**CITY OF SEATTLE  
ANALYSIS AND DECISION OF THE DIRECTOR  
OF THE DEPARTMENT OF PLANNING & DEVELOPMENT**

**Application Number:** 3011405  
**Applicant Name:** John Adams, Stuart Silk Architects  
**Address of Proposal:** 324 NE 45<sup>th</sup> St

Land Use Application to allow a four-story structure containing one residential unit, 4,860 sq. ft. of office and 13,312 sq. ft. of retail. Parking for six vehicles to be provided within the structure. Project includes 1,800 cu. yds. of grading.

PERSPECTIVE VIEW FROM THE SOUTHEAST

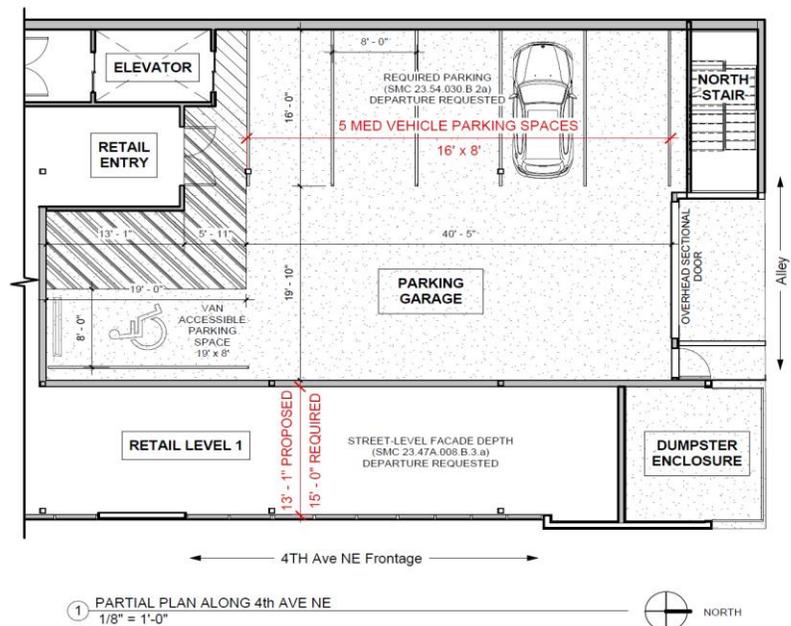
**At the Final Recommendation Meeting, the Board indicated that the proposal took advantage of the rights-of-way conditions for landscaping. They suggested working with Seattle’s Department of Transportation on the street tree selected and the tree pit design. If possible they suggested the use of ‘evergreens’ on 4<sup>th</sup> Ave NE. The landscaping strip or tree pits need to be design to protect the materials installed.**

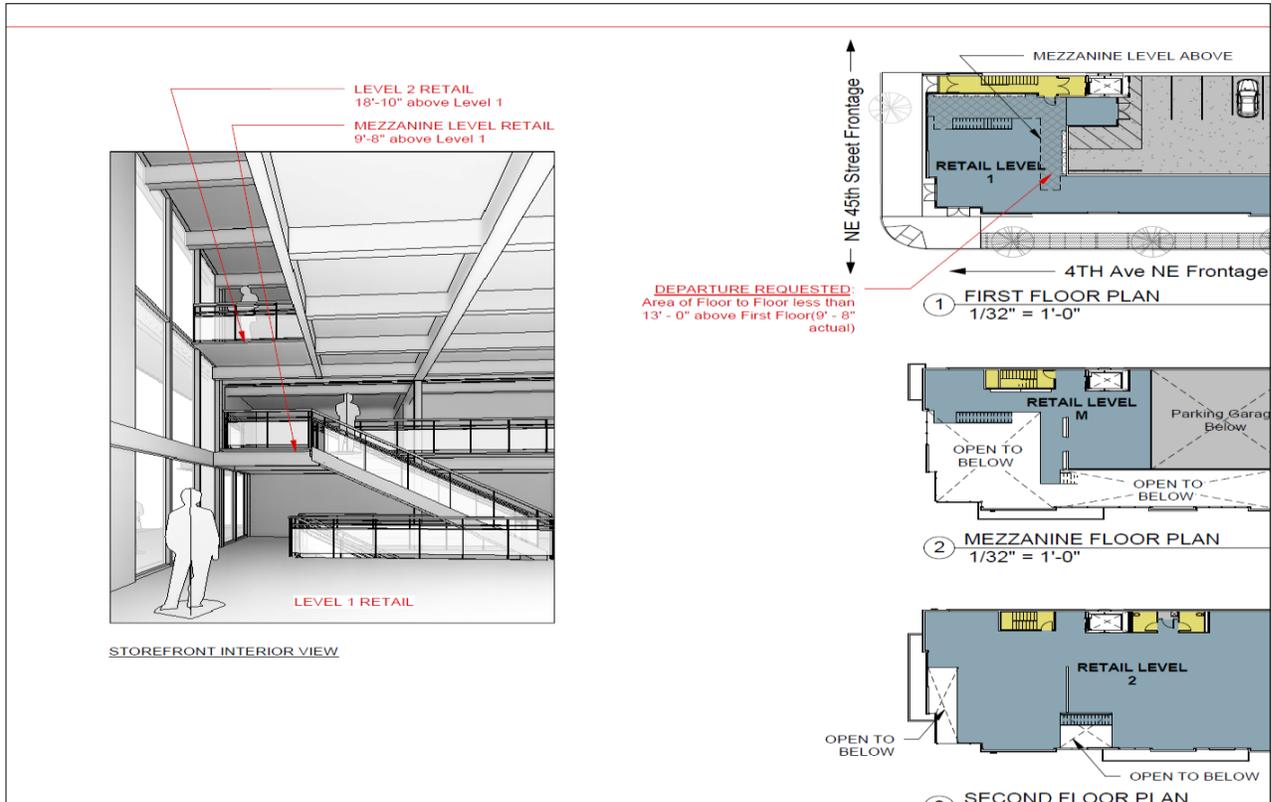
2. **STREET-LEVEL DEVELOPMENT STANDARDS (SMC 23.47A.008 B.3.):** The Code requires nonresidential uses shall extend an average depth of at least 30 feet and a minimum depth of 15 feet from the street-level street-facing façade. The applicant proposes 13 feet along 4<sup>th</sup> Ave NE.

Due to the narrowness of the site and the desire to use the retail frontage of the building to screen the parking area it is not possible to make the façade along 4<sup>th</sup> Ave NE the full 15 foot depth, unless the parking area behind is modified. (*Guidelines A-2, A-4, A-10, C-1, C-2, D-11, and D-12*).

The Board indicated they were favorable towards the departure — see item 1 above and item 3 below.
